TAYLOR POINTE SUBDIVISION, UNIT TWO, PART C **RESUBDIVISION OF LOT 51**

APPLICATION NUMBER 9 DATE December 3, 2015
APPLICANT Taylor Pointe Subdivision, Unit Two, Part C, Resubdivision of Lot 51
REQUEST Subdivision

DETAIL SITE PLAN

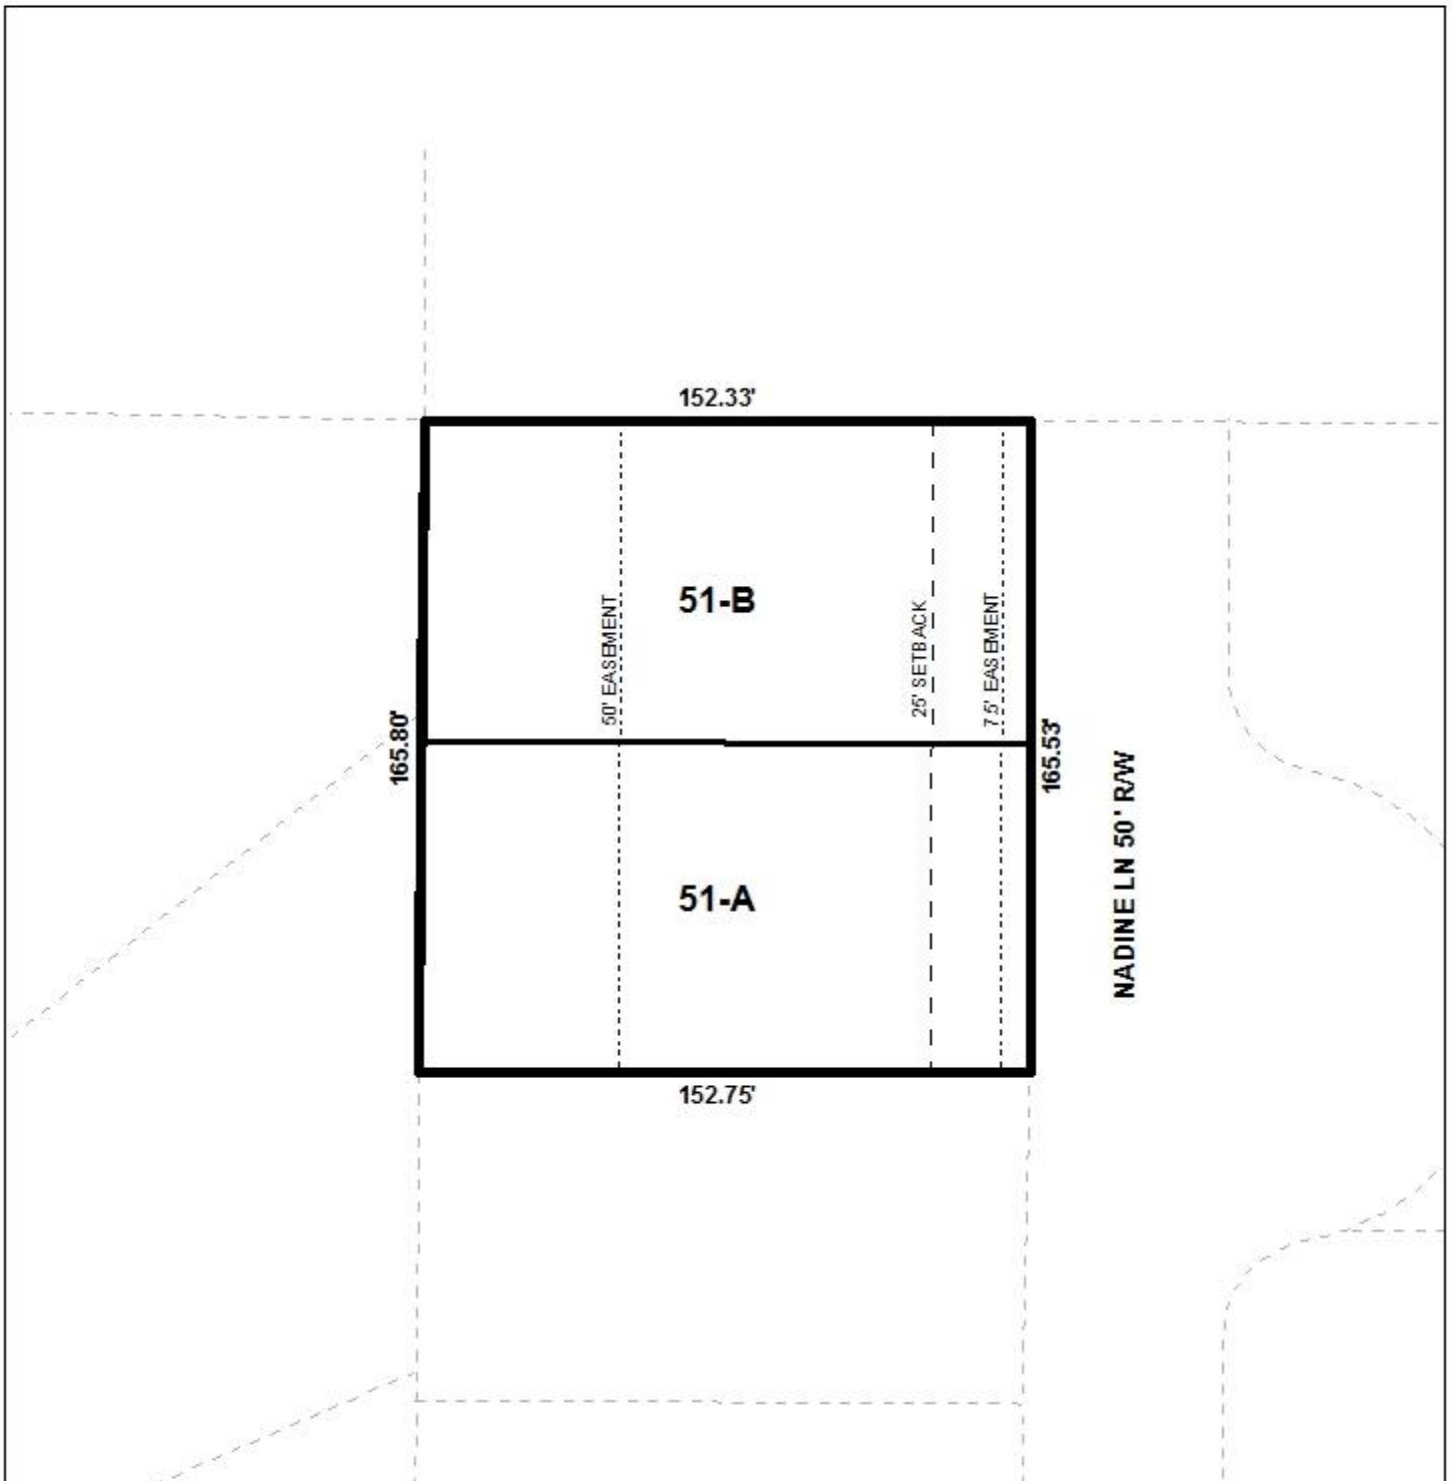
As a means of access management, a note should be required on the Final Plat stating that each lot is limited to one curb cut to Nadine Lane, with their sizes, locations and designs to be approved by Mobile County Engineering and conform to AASHTO standards.

The preliminary plat indicates a 25' building setback line for each of the proposed lots as required by Section V.D.9. of the Subdivision Regulations. If approved, this information should be retained on the Final Plat. It should be noted that the preliminary plat illustrates a 7.5' easement along the front property line, and a 50' easement along the rear property line. A note should be placed on the site plan, as well as the Final Plat if approved, that no structures will be erected in any easement.

Each lot meets the minimum size requirements of the Subdivision Regulations and is labeled in square feet, but not acres. If approved, each lot size should be labeled with its respective size in both square feet and acres on the Final Plat, or a table should be furnished on the Final Plat providing the same information.

The site is located in the county. Therefore, a note should be placed on the final plat stating that any lots developed commercially and adjoin residentially developed property must provide a buffer, in compliance with Section V.A.8. of the Subdivision Regulations.

The site will have to comply with the City of Mobile storm water and flood control ordinances. A note stating *“Must comply with the Mobile County Flood Damage Prevention Ordinance. Development shall be designed to comply with the storm water detention and drainage facility requirements of the City of Mobile storm water and flood control ordinances, and requiring submission of certification from a licensed engineer certifying that the design complies with the storm water detention and drainage facility requirements of the City of Mobile storm water and flood control ordinances prior to the issuance of any permits.”* should be placed on the Final Plat.

- 1) placement of a note stating that each lot is limited to one curb cut to Nadine Lane, with their sizes, location, and design to be approved by Mobile County Engineering and conform to AASHTO standards;

- 2) retention of the building setback line for each lot on the Final Plat;
- 3) placement of a note stating that no structures shall be erected in any easement;

- 4) revision of the Final Plat to indicate the lot sizes in both square feet and acres, or the furnishing of a table on the Final Plat providing the same information;

- 5) provision of 7 copies of the recorded plat for Taylor Pointe Subdivision, Unit Two, Part C prior to the signing of the Final Plat;
- 6) placement of a note on the Final Plat stating that any lots which are developed commercially and adjoin residentially developed property must provide a buffer, in compliance with Section V.A.8. of the Subdivision Regulations; and

- 7) placement of a note on the Final Plat to comply with the Mobile County storm water and flood control ordinances: (*“Must comply with the Mobile County Flood Damage Prevention Ordinance. Development shall be designed to comply with the storm water detention and drainage facility requirements of the City of Mobile storm water and flood control ordinances, and requiring submission of certification from a licensed engineer certifying that the design complies with the storm water detention and drainage facility requirements of the City of Mobile storm water and flood control ordinances prior to the issuance of any permits.”*); and
